R-11-211 Committee Amendments

The attached amendments to the Volcano Trails Sector Development Plan were adopted by the Land Use, Planning and Zoning Committee on May 11, 2011 and June 15, 2011

COMMITTEE AMENDMENT NO. 1 **TO** R-11-211

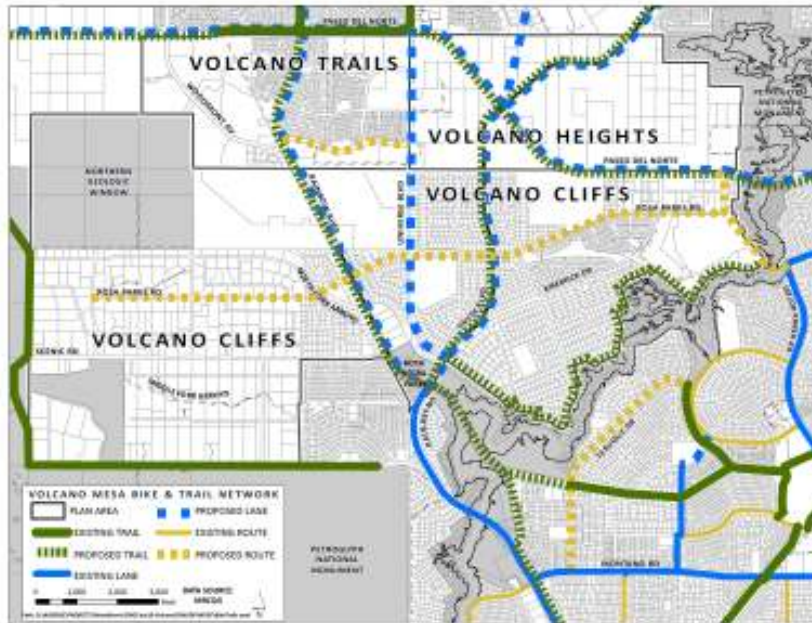
14. On page 8 delete Exhibit 7 and insert in lieu thereof the following exhibit. Change the title so that it reads “**Exhibit 7, Volcano Mesa Bike & Trail Network**”. Make changes as appropriate to the table of contents.

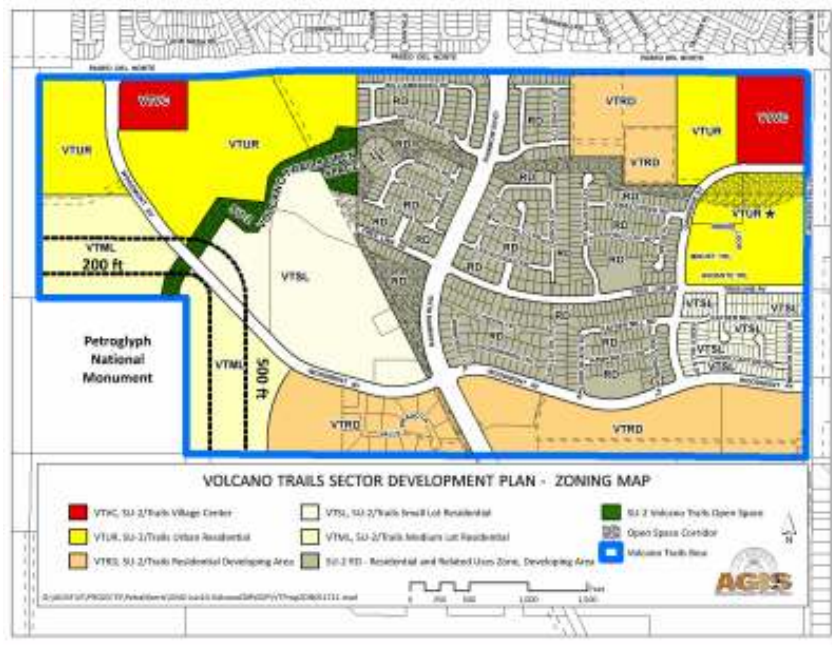
1. On page 5 delete Exhibit 4 and insert in lieu thereof the following:

2. On page 5 add a new note underneath Exhibit 4 that says: “* NOTE: Cantata @ the Trails is NOT exempt but does warrant specialized zoning regulation, as its site plan was approved by the Development Review Board (DRB) based on zoning from a prior planning effort. (See **Chapter 3 Section I – Zoning** Pre-existing Standards for Development.)”
3. On page 5 add a new note underneath Exhibit 4 that says: “***NOTE: Valle Vista @ the Trails Unit 2 is NOT exempt except for lot size, as it was platted prior to the latest planning effort.”
4. On page 21 in the second line of the third bullet delete “5,000 square feet” and insert in lieu thereof “3,600 square feet”.
